Project Number 11045
Purpose Subject Area Committee Meeting: Food Service
Location Bean Hall East Conference Room
Start Time 2/23: 3:00 PM

CONFERENCE REPORT

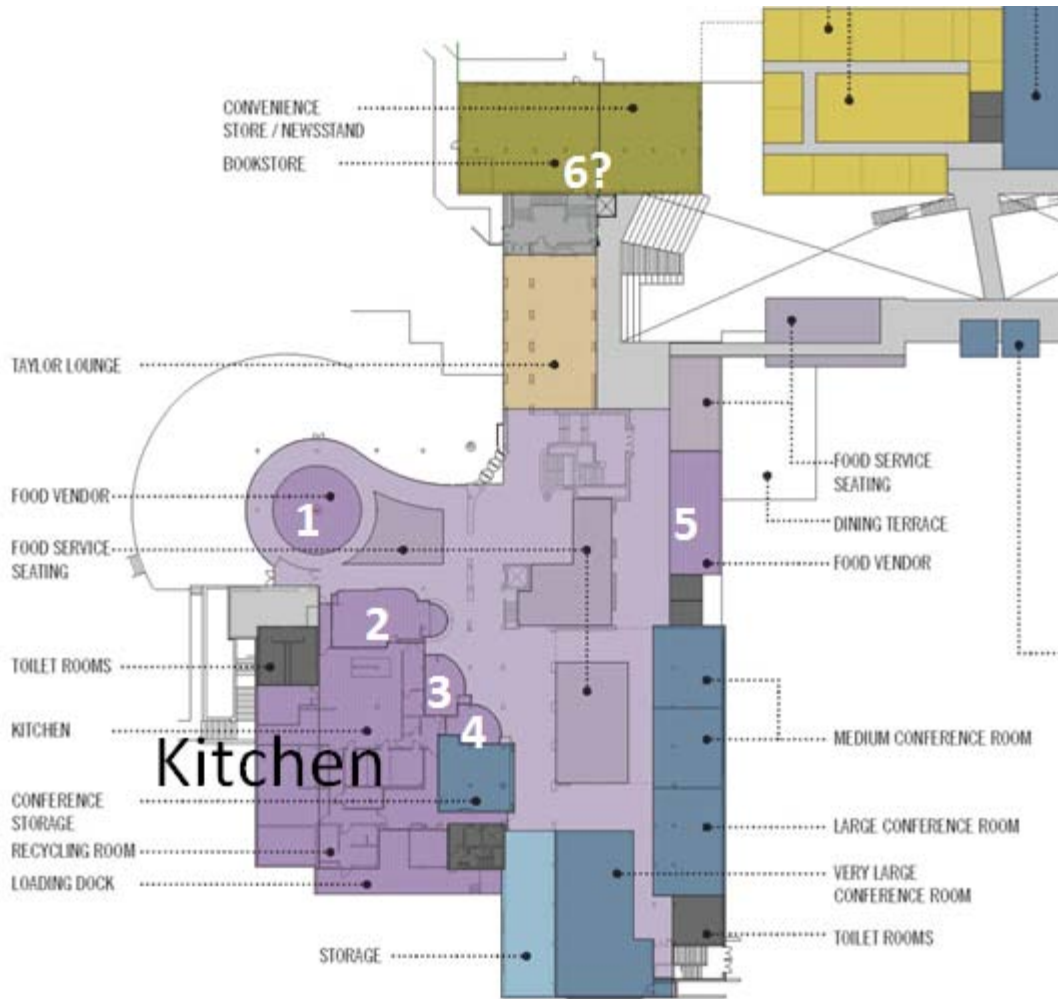
- b. Concern was expressed to make sure that seat counts match or exceed those highlighted, since there is some overlap with students using seats for studying/gathering or non eating functions.

- c. Peg calculates demand for Food service is 580 seats, based upon a 75% efficiency ratio.
- d. Peg and Chris suggested a variety of seating types to accommodate short and long term, small and large groups, such as 2-top and 'family style' tables.

- e. 2 tops create more flexibility and accommodate more demand in contrast with larger tables. Counter seats should be deep enough for laptops and allow for single patrons seats used for study. The goal is to allow multipurpose uses of seating in the food areas, not just for eating.

- f. Booths are very popular with students.
- g. Atrium (fountain court) seats not counted for food service.
- h. Food service seating areas are shown highlighted in green below:

Coffee House:

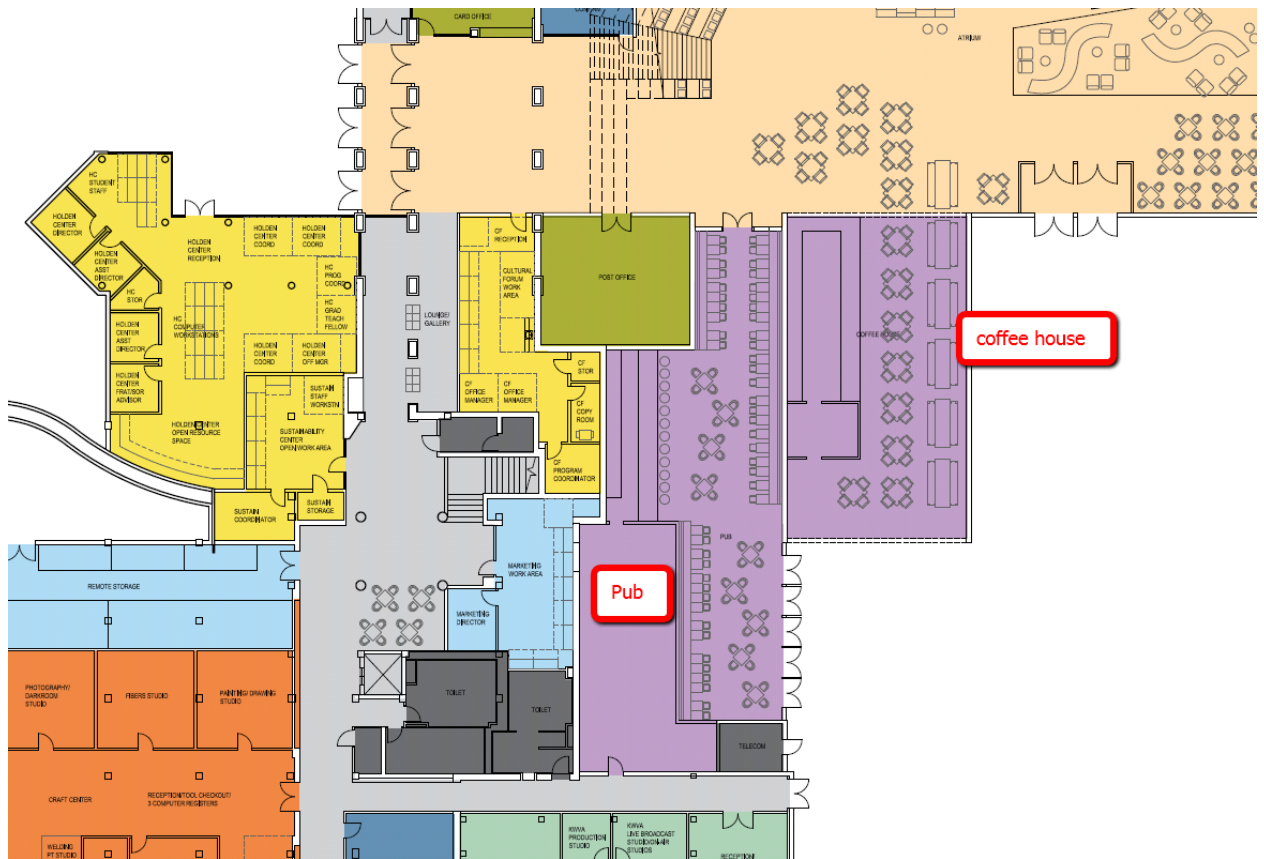
13. The coffee house location at the atrium level (440 elevation), is a key atrium activator. Seating will spill out into the atrium. It is envisioned to also have cooking capability to serve 3 meals a day, in addition to feature coffee and pastries to go. It is planned to be self operated by EMU Food Service, but should be flexibly designed to be self contained, in the event it ever becomes an outside operator.

- a. Front and back of house needs to be laid out to confirm seat count and proper equipment and support. Jean Michel to do initial layout for review.
- b. It was also envisioned for the coffee house to feature outdoor seating.
- c. Servicing will be challenged, given its distance from the loading dock. Due to space limitations on the lower level, some of the storage could potentially be reassigned and located with the central production area upstairs.
- d. Patrons could order at the counter, take a number, then food delivered to their table.
- e. images of the coffee house off the atrium are shown below:

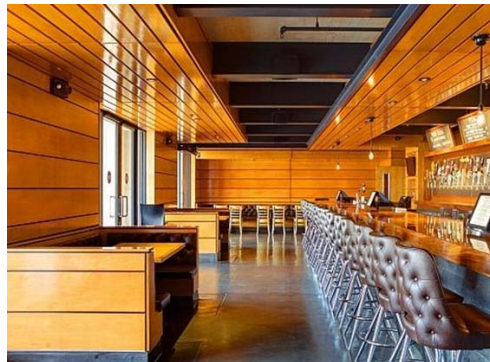
14. The pub was reviewed, and noted that would be nice if it could also have the capability of spilling outside, and have direct exterior access. Additionally it could benefit from access from the atrium. This means eliminating the north south corridor that separates it from the exterior wall.

- a. The pub was envisioned with food and alcohol at lunch and dinner for all patrons, then for late night, to be 21 and over service. Similar to the coffee house, it is planned to be self operated by EMU Food Service, but should be flexibly designed to be self contained, in the event it ever becomes an outside operator.

- b. Jean Michel to do initial layout for review.
 - c. Similar to the coffee house, patrons could order at the bar, take a number, then food delivered to their table.

- d. Pool tables/gaming was also originally envisioned here, but is not accounted for in the food service nest square foot allocation.
 - e. Ideally the hood exhaust will be combined with coffee house exhaust and the venue directly above on Level 1.

- f. A revised layout below was developed after the meeting to show new relationship with corridor eliminated:
